SALEM COUNTY IMPROVEMENT AUTHORITY

RESOLUTION OF THE SALEM COUNTY IMPROVEMENT AUTHORITY
AUTHORIZING CHANGE ORDER #2 TO THE CONTRACT
FOR CONSTRUCTION OF THE METHANE GAS COLLECTION
SYSTEM INFRASTRUCTURE

Date of Issuance: July 3, 2024	Effective Date: July 3, 2024
Owner: Salem County Improvement Authority	Owner's Contract No.: 2024-44
Contractor: Atlantic Lining Company, Inc.	Contractor's Project No.: 240056
Engineer: SCS Engineers	Engineer's Project No.: 02218820.06
Project: 2024 GCCS Expansion	Contract Name:

Work Change Directive

SCIA PH-10B MODIFICATIONS

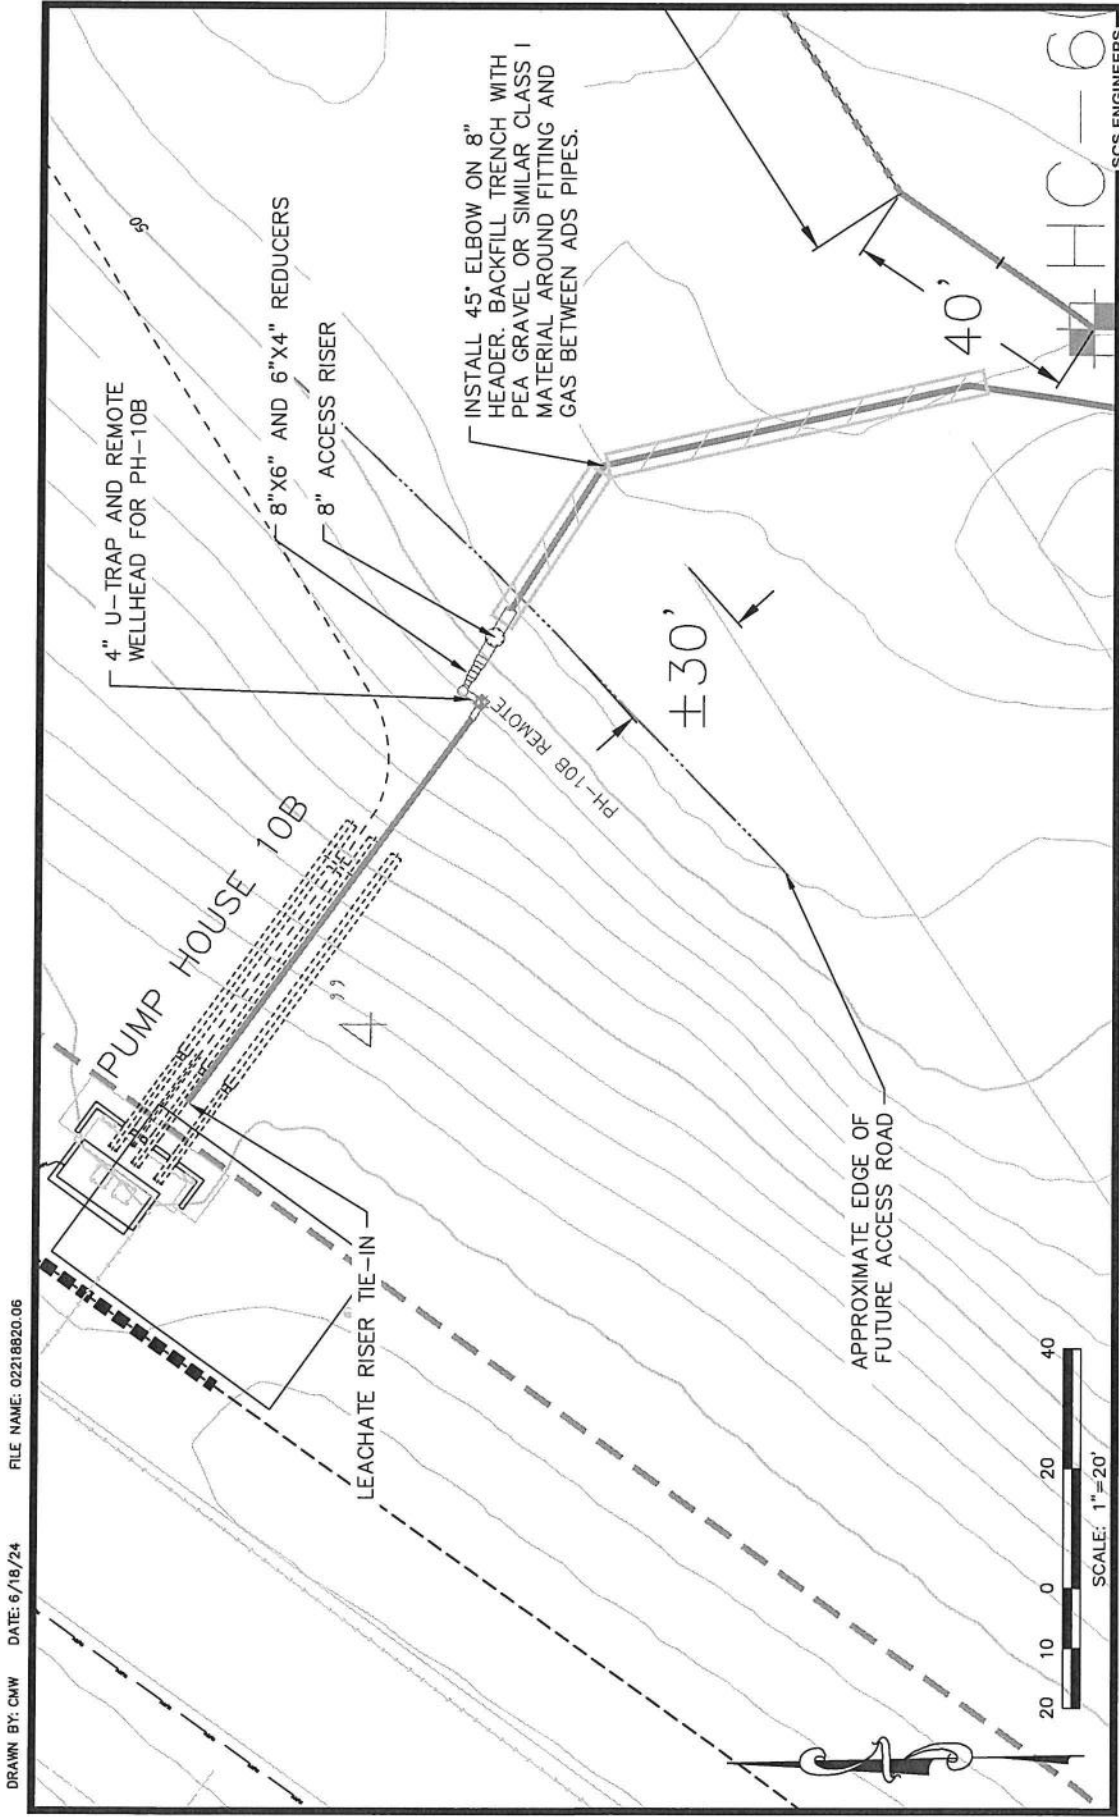
Item No.	Description
WCD 1	1. Extend Road Crossing approximately 33 feet (\$152/ft)
	2. Modify remote well head for PH10B to add u-trap
	3. Change flanged connection to vertical position
	4. Add stone and soil to increase cover over ADS encasement pipe to a minimum of 2 feet. Grade to transition hump in road for traffic

Revised Road Crossing Plan and Detail – Upslope from Pump House 10B
